STEREO CONFIGURATION CHANGE REQUEST

IMPACT Accoustics Waiver

SEPT Colimator and detector mount

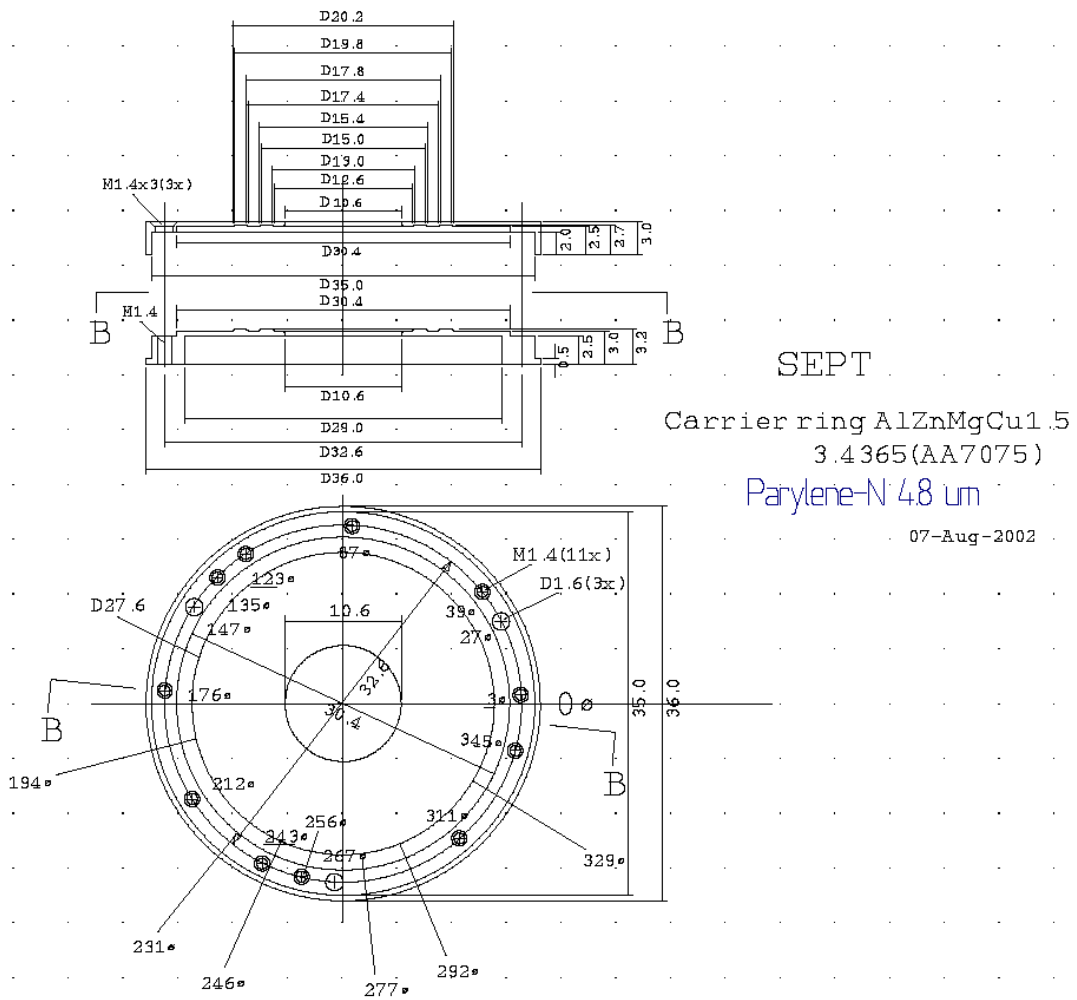
<input type="checkbox"/>	Reliability	<input checked="" type="checkbox"/> Specification Requirements	<input type="checkbox"/> New Document:	<input type="checkbox"/> Yes
			<input type="checkbox"/> Other:	
PROPOSED CHANGE (Attach additional pages as required):				
<p>The STEREO Environmental Requirements Document (7381-9003 rev B) section 3.4.3 specifies acoustic testing requirements for instruments:</p> <p style="padding-left: 20px;">Instruments that are susceptible to acoustic energy (e.g.: have thin foils) shall verify their capability to withstand the observatory level testing. Specific instrument acoustic test requirements are shown in Appendix B.</p> <p>Appendix B calls out acoustic tests for a number of IMPACT instruments including SIT, SEP Central/HET/LET, SEPT-E, SEPT-NS, SWEA, STE-U and STE-D. We propose not to do acoustic testing on SEPT-E, SEPT-NS, SWEA, STE-U and STE-D.</p>				
RATIONALE (Attach additional pages as required):

<ol style="list-style-type: none"> 1. SWEA, STE-D, and STE-U contain no thin foils or other fragile parts sensitive to acoustic energy. 2. SEPT-E and SEPT-NS do have paralene foils. We use 4.8 micrometer thick Parylene N foil with 100 nm Al on both sides, mounted on user supplied frames (see attachment). Tensile strength is 6,500 psi (test method: ASTM-D882), Elongation is 30 % (test method: ASTM-D882), Specific gravity is 1.12 g/cm³ (test method ASTM-D1505), Modulus is 350,000 psi (test method: ASTM-D790). We have designed the carrier ring and fabricated it in our mechanical workshop (see attachment). The ring mount is designed to exert a uniform load radially outward. Although Parylene shows high resistance to creep, minor foil sagging may occur from differing coefficients of expansion of the ring and film (6.9 10⁻⁵ /°C). Hole perimeter is rounded off, any burrs are carefully removed. On 11/12-NOV-2003 we have performed an acoustic noise test on SEPT EM for the sole purpose of qualifying the foil and carrier ring design. The noise levels according to 7381-9003 were applied. SEPT EM passed the test. Test report is available on request. We flew similar foils on Wind in nearly the identical configuration without problems. More information attached. <p>We had never planned on doing these tests based on the wording of section 3.4.3. Adding them will have cost and schedule impacts.</p>

Since we propose acoustic tests only on a representative sample foil, it is important that all the foils have similar properties. The SEPT paralene foils were manufactured onto IMPACT-provided frames by the Lebow company in California. Representative measurements of the foil material showed remarkably uniform thickness: 4.95 microns +/- 0.2 microns. In response to a query about the repeatability of the foil production process the company states:
